Village of Arlington Heights
Conceptual Plan Review Committee
Community Room, 3rd Floor
Arlington Heights Village Hall
33 S. Arlington Heights Road
Arlington Heights, IL 60005
August 23, 2017
6:30 PM

To: Conceptual Plan Review Committee

Meeting Date: August 23, 2017

CONCEPTUAL SITE PLAN
SCALE: 1" = 30'-0"

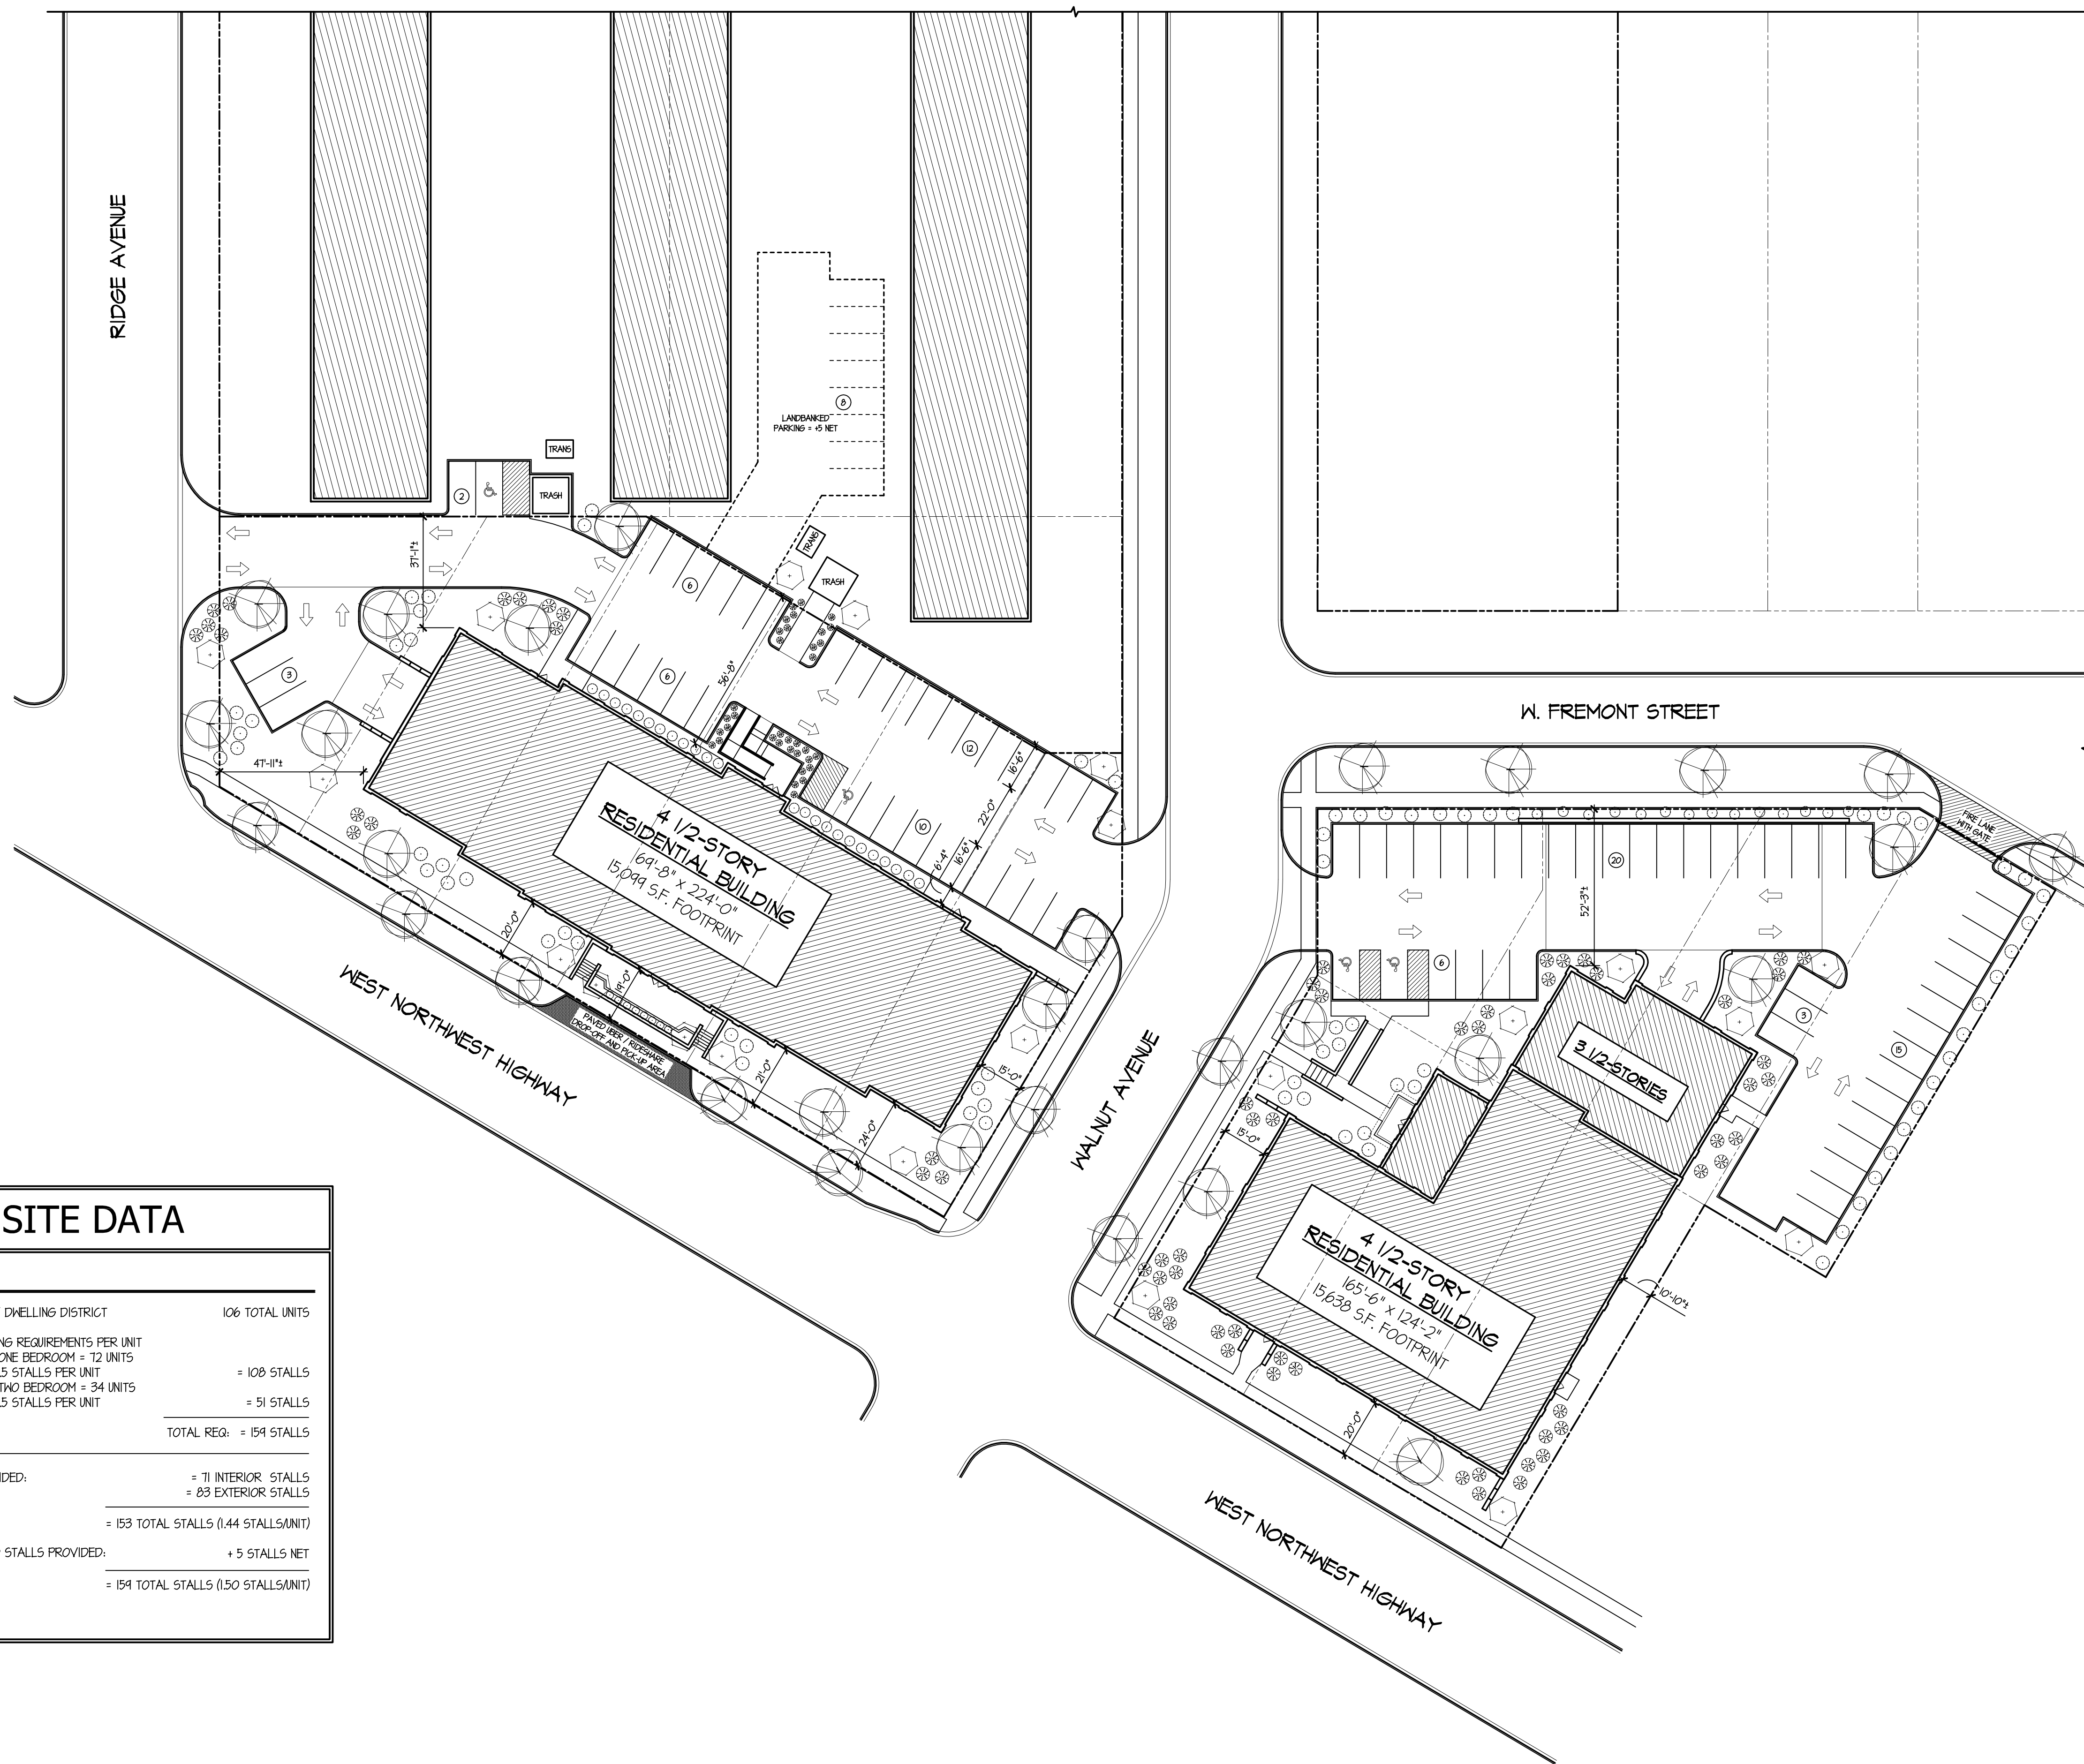
Both the east and west buildings appear to conform to all bulk, height, and density restrictions, however, certain variations from setback regulations are required (see Exhibit I at the end of this report). Staff has worked with the petitioner to increase the building setbacks (from those originally presented) to minimums as deemed acceptable for a building of the proposed size, however, there are several areas of the plan that are recommended for further analysis and revisions as indicated below.

At the request of staff, the developer has lowered the 1st floor of both buildings to be 50% below grade, which will help to reduce the mass of the structure and screen the blank walls along Northwest Highway. The Petitioner has proposed to raise the grade at the front of the buildings to screen their base so that the foundation would begin approximately 4' below grade along Northwest Highway (see elevations). Further analysis on the feasibility of this grade change is needed as 20' of space may not be adequate to accommodate such a grade change. In addition to this change, staff recommends the inclusion of dense landscape plantings in the greenspace along Northwest Highway to further enhance the appearance of the building along this heavily trafficked corridor. Finally, the developer has recently proposed an enhanced southern entry to the west building, which will help to break up the massing of the structure as viewed from Northwest Highway.

In response to staff concerns, the petitioner has recently revised the entry area of the east building to provide a more defined front entry. This has caused the garage entry to shift to the north elevation of the building, which improves the flow of automobiles throughout the site. As the garage entrance will now face to the north, a heavy landscape screen should be added along the northern property line to shield the homes to the north from the glare of headlights in the evening. In order to enhance the open space by the front entry, a robust landscape program in this area should be incorporated into the landscape plan.

As noted above, dense landscaping should be incorporated along Northwest Highway to provide a buffer for the building and to enhance the appearance along this major arterial street. The petitioner should also provide dense plantings along the rear of each parking area to screen their appearance from the residential areas to the rear. Previous iterations of the plan showed a carriage walk on the western site where the property abuts Northwest Highway. At the request of staff, the petitioner has relocated this sidewalk to provide a parkway in-between the sidewalk and Northwest Highway. An easement to the Village for any portion of the public sidewalk that overlaps onto private property must be granted in conjunction with this development. IDOT approval will be needed for the proposed drop-off area in front of the west building, which will also need further evaluation.

In a response to neighborhood concerns, the developer has lowered each building by approximately four feet. Additionally, the east building has been tapered down along the rear where the building extends out towards the primarily single-family residential area to the northeast. Originally, this section of the building was proposed at 5-stories in height and is now proposed at 3.5-stories. The developer should note that overall building height (from a zoning perspective) will be measured from the average grade at the sidewalk (adjacent to the front yard) to the top of the roof, and not from the elevation of grade at the top of the berm to the top of the roof.

The developer has proposed the landbanking of nine parking stalls on the Arlington Garden apartment site located immediately north of the west building, which apartment complex is also owned by the developer. When factoring in these landbanked spaces, the site conforms to all parking requirements. In order to provide the landbanked parking, additional landscape islands may be needed within the proposed parking lot to comply with code requirements, which may cause the elimination of an additional one or two parking spaces.

While staff supports the provision of a contingency plan outlining additional opportunities for on-site parking in the event of a parking shortage, the location of the landbanked parking is not optimal and would diminish the open space and landscaped area within the Arlington Garden site. Squeezing the code-required parking onto the Arlington Garden property is not a suitable solution, and the petitioner should further analyze the ability of both the east and west sites to accommodate the code required parking on their site. The developer may wish to explore alternative locations for additional parking spaces, and/or a revised site layout that

Following up on the e-mail below, we remain ready for early review. We do have some changes to the East building based on our neighborhood meeting at which 3 major concerns were voiced; exits on Park and Fremont and resulting traffic; parking; building height. There were no concerns raised regarding the West building so there are no changes to the West building plans previously submitted. Attached is a revised site plan with a revised floor plan for the East building.

Exits on Park and Fremont and resulting traffic appeared to be the biggest concern. In response we have flipped the building to the orientation of the original proposal and moved the exit to Walnut to align with the West Building.

Parking appeared to be the next biggest concern. In response we have removed the 6 northernmost units on the top floor from the East building. This will eliminate the need for a parking variance as both buildings will now be at 1.5 stalls per unit which is within code and well within the KLOA recommendation of 1.1 stalls per unit.

Building height and density was a close third. The removal of the above referenced units is also responsive to this concern. Further the lower portion will be closest to the neighbors. This approach will allow for symmetry along Northwest Highway.

SITE PLANS

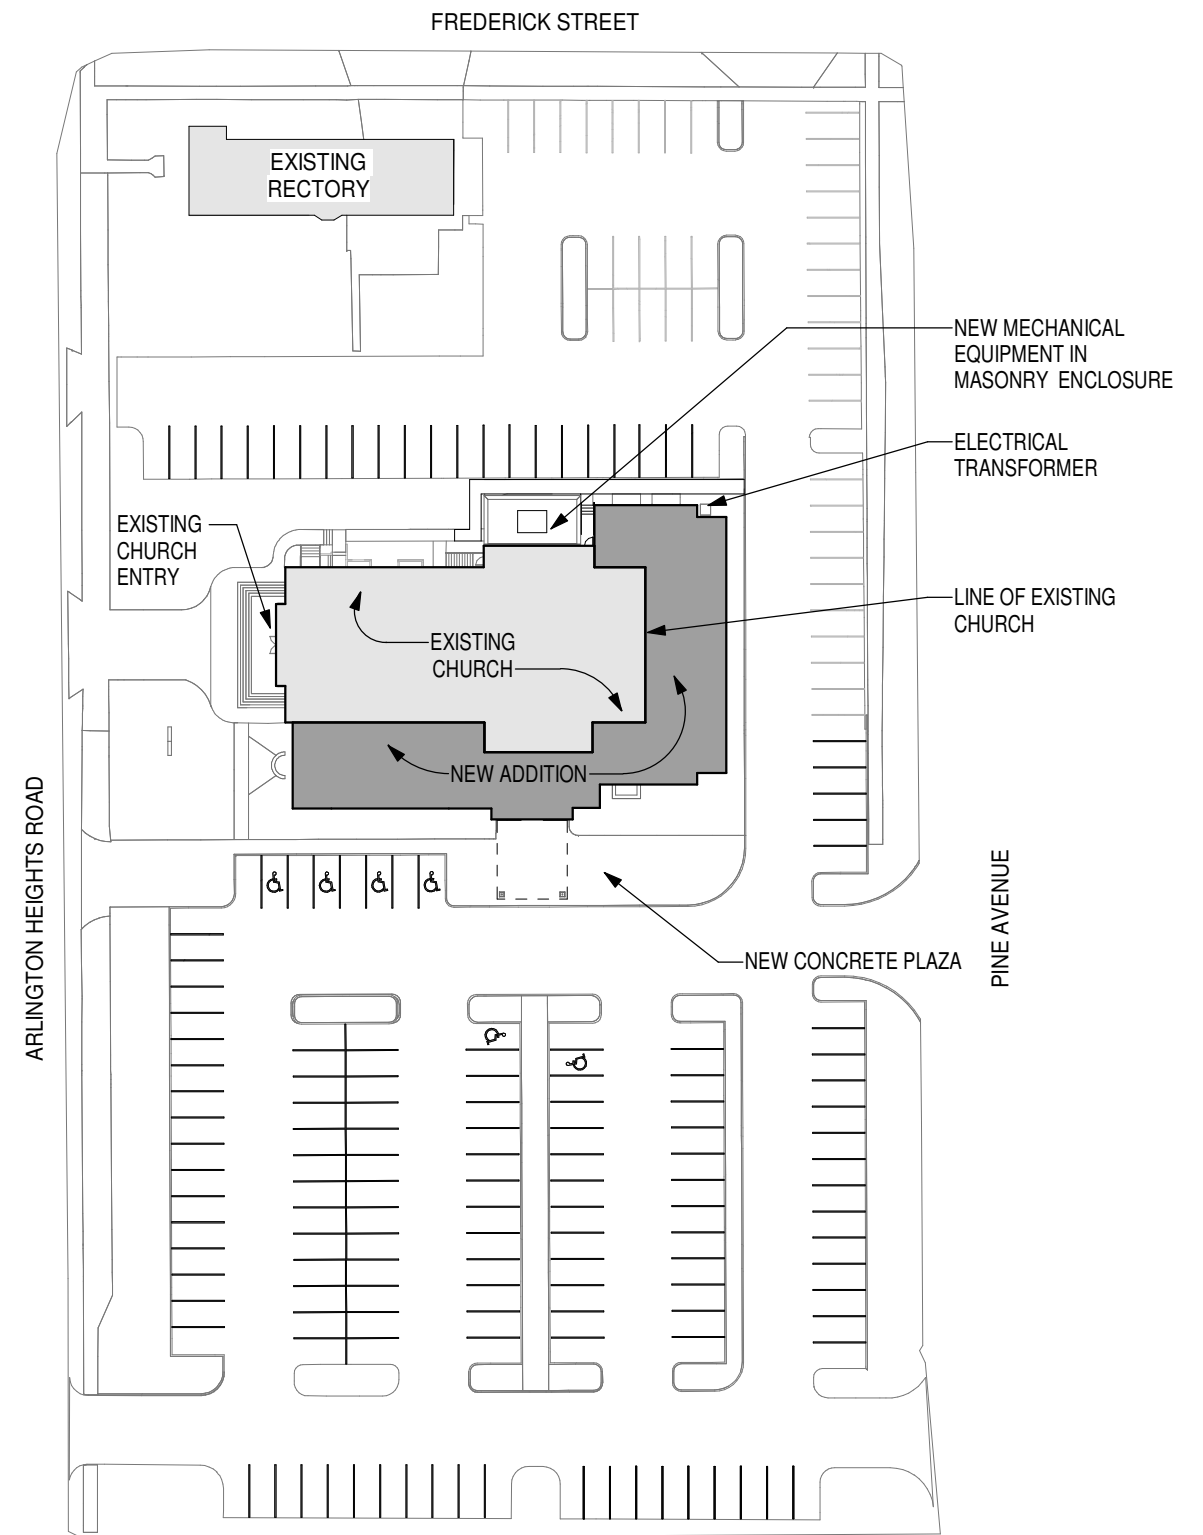
Original conceptual plans showed the addition of an underground stormwater detention vault beneath the parking lot to accommodate for the expected stormwater runoff. However, the current version of the plans no longer proposes the underground detention vault and instead show a dry bottom detention basin at the southern end of the site immediately abutting the residential homes to the south. Staff notes that both

underground detention and above ground detention are allowed by Village Code. If the underground detention vault is re-integrated back into the site design, the above ground detention area could be removed and additional parking could possibly be included in this area (if needed), in combination with a dense program of landscape plantings to screen the use from the residential homes to the south. If the petitioner elects to move forward with the above ground detention area, a heavy landscape screen around the perimeter of the basin will be required.

The proposed site plan does not show an area for refuse collection. Careful consideration of the siting for this dumpster enclosure is needed in order to provide the necessary screening and distance from residential areas, as well as to provide for adequate room for the turning requirements of a scavenger truck. Revised plans showing the proposed location of the dumpster enclosure will be required as part of the formal Plan Commission application.

Preliminary analysis of the proposed parking indicates that a parking Variation will be needed, which is typical of many of the older churches within Arlington Heights. The extent of this particular Variation is still being evaluated, and further details may be available at the Conceptual Plan Review meeting.

With regards to the extended parking area, we are pleased to note the addition of approximately 50 parking spaces on this side of the campus. These additional parking spaces exceed the number necessary for the additional seating being provided in pews.
